Addendum #1

ITB # 4342

Summit Street 16" Water Main Replacement  
Through Wheeler Park

Monday, August 11, 2014

**WATER MAIN PLAN AND PROFILE**

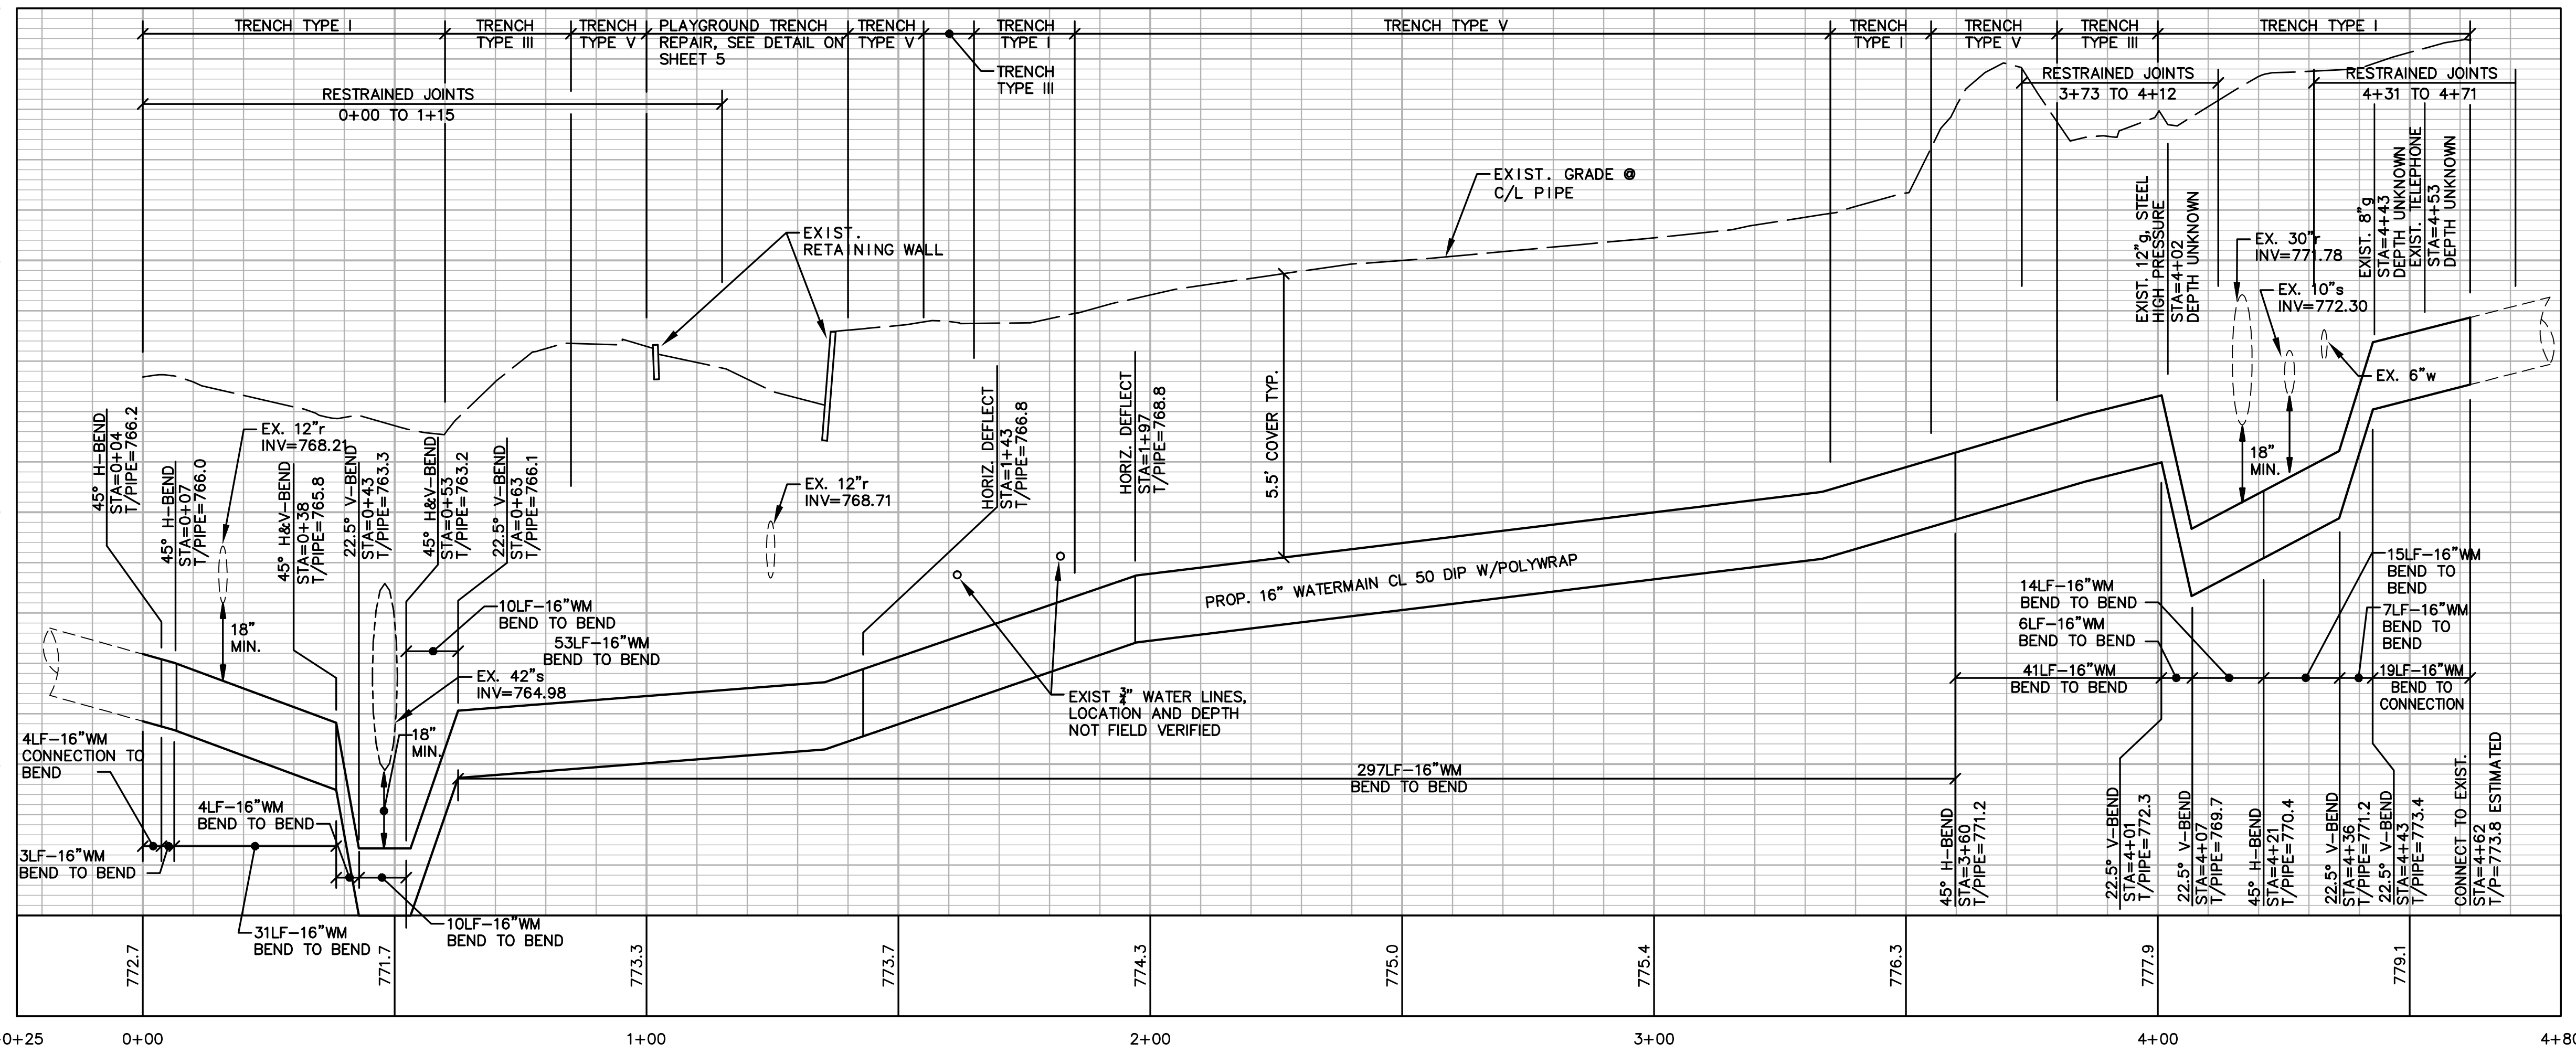
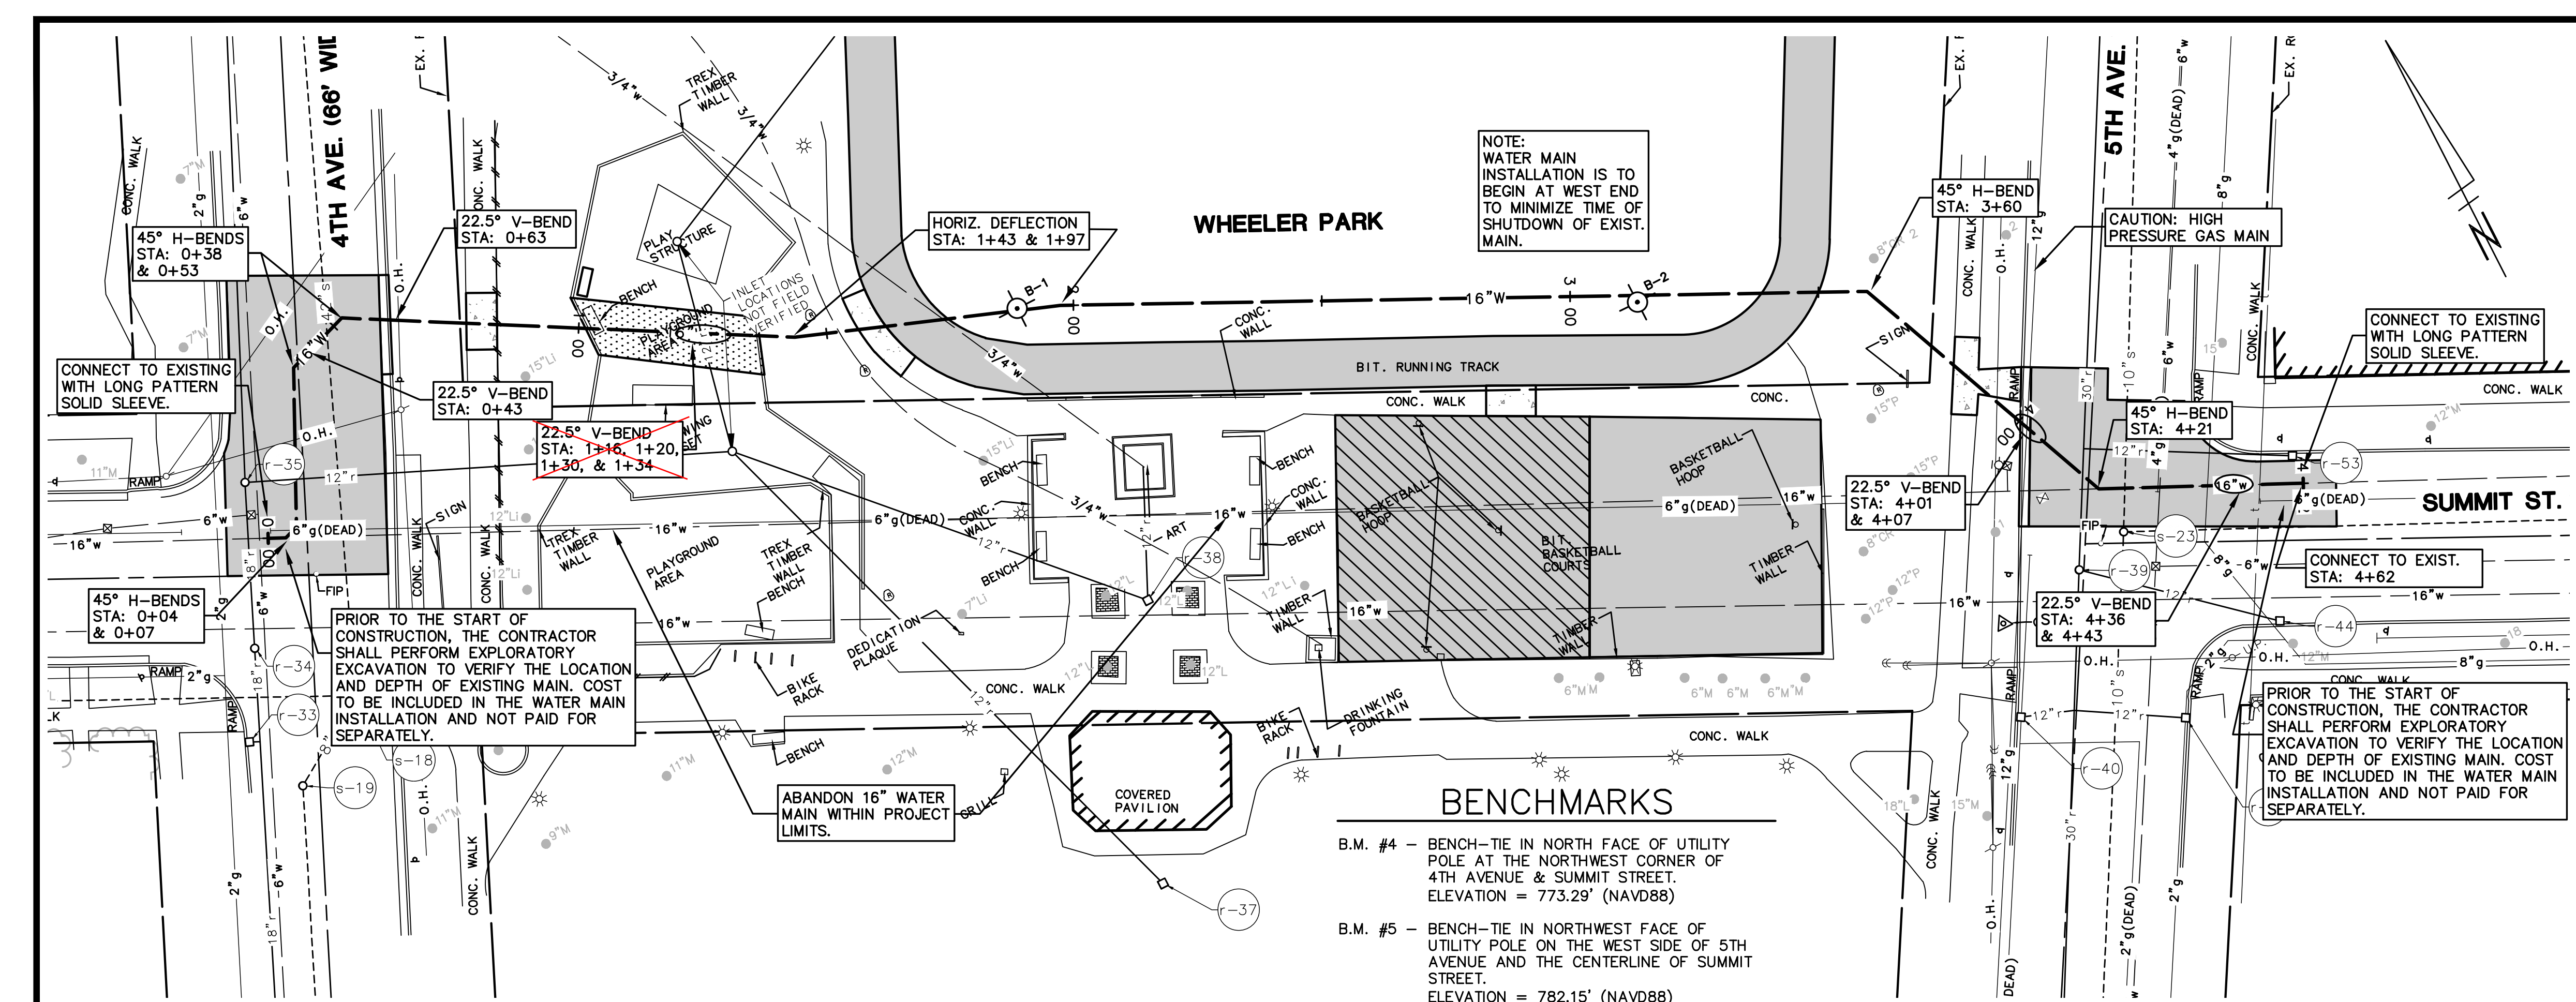
1. The quantity of item #410, 16" Class 50 DIP Bends, has been revised from 8 to 12.
2. Revised bid forms are attached and are pages APP-1 and APP-2.
3. Sheet 5 has been revised to eliminate the plan view note which stated "22.5° V- BEND STA: 1+16, 1+20, 1+30 & 1+34". A copy of that plan sheet with the note marked out is also attached.
4. Please remember to acknowledge this addendum within your bid documents.
